Bureau of Land Management Colorado River Valley Field Office Minerals Inspection Report

General Information	
Date	3/7/2018
Project Name	Mid-Continent Limestone Quarry
Operator	RMR Aggregates, Inc.
Serial Number	COC-074205
Project Classification	Plan of Operations
Project Location	T5S R89W Sec36, Garfield County
Inspection Purpose	Regular site inspection (per 43 CFR 3809.600 (a))
Time Period Onsite	2.5 hours
Attendees	Jessica Lopez Pearce, BLM Geologist
	Bobby Wagner, RMR Aggregates, Inc. Director of Operations
	Justin Olin, RMR Aggregates, Inc. Mine Superintendent

Photo 9. Looking north from central mill bench photo point

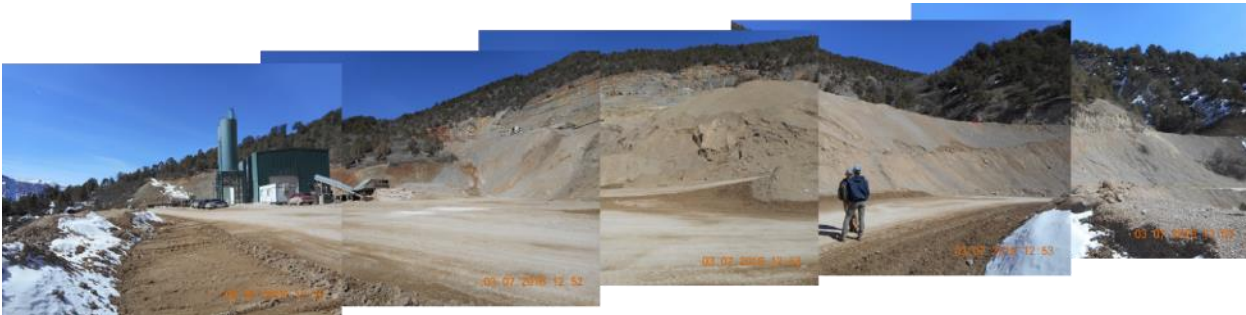
On the mill bench, I took photos from my established photopoint.

Map 1. Dec 2016 exploratory drill holes (map created by A. Yeldell, DRMS, 1/14/2018).

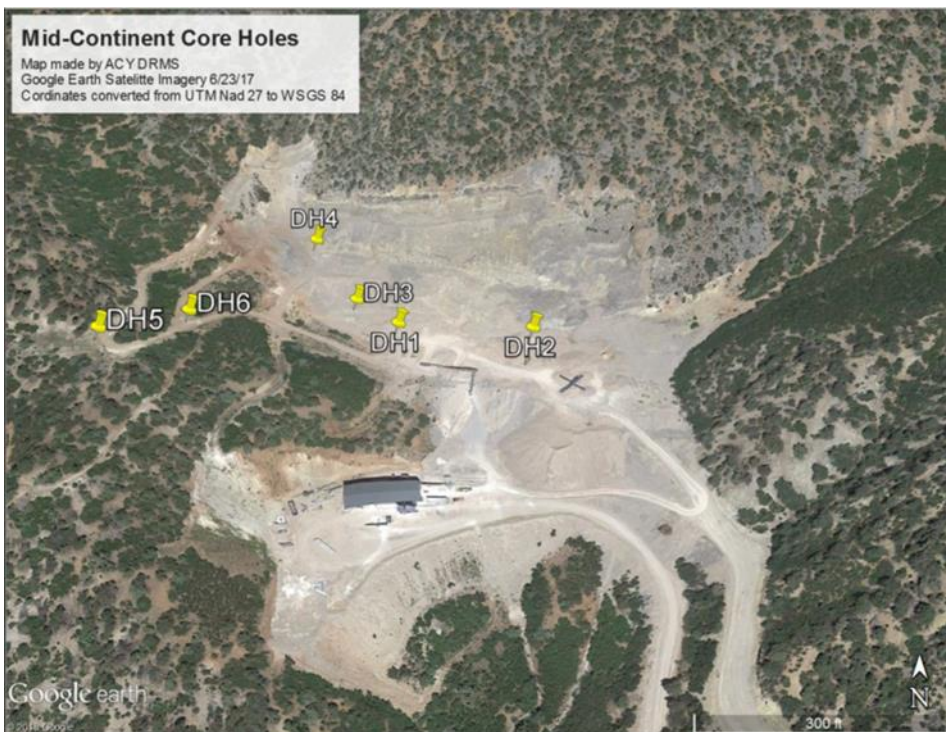
On January 19, 2018, I was informed that RMR had conducted exploratory drilling in December 2016. This drilling was performed without BLM authorization. The drilling consisted of six exploratory drill holes (no coring) within the DRMS-approved permit boundary. The holes had been backfilled with cuttings and the surface disturbance reclaimed. The 1982 Plan of Operations for the Mid-Continent Quarry does not include an exploration component and there is no existing authorization for exploratory drilling within or around the quarry perimeter in the August 18, 1982 Plan of Operations approval. There is a brief reference to exploration having been conducted between 1983-1985 in the 1989 Plan of Operations modification (AM-1); however, there is no record of approval for this activity in the July 21, 1989 Plan of Operations modification approval. On January 31, 2018, BLM sent email correspondence requiring RMR to contact BLM prior to any future exploratory drilling.

During this inspection, I visited two of the reclaimed 2016 exploratory drill holes; drill holes #5 and 6. Surface evidence of the remaining four holes (drill holes #1, 2, 3, and 4) had been obliterated by subsequent blasting operations. Drill hole #6, located on the western access to the upper mine benches, had some moisture-related material swelling at the surface but no other evidence of surface disturbance. Drill hole #5, located on the access to the upper-most mine bench, had a larger volume of cuttings remaining on the surface. All six drill holes were located within existing disturbance. RMR stated that water was not encountered during drilling operations for any of the six holes.
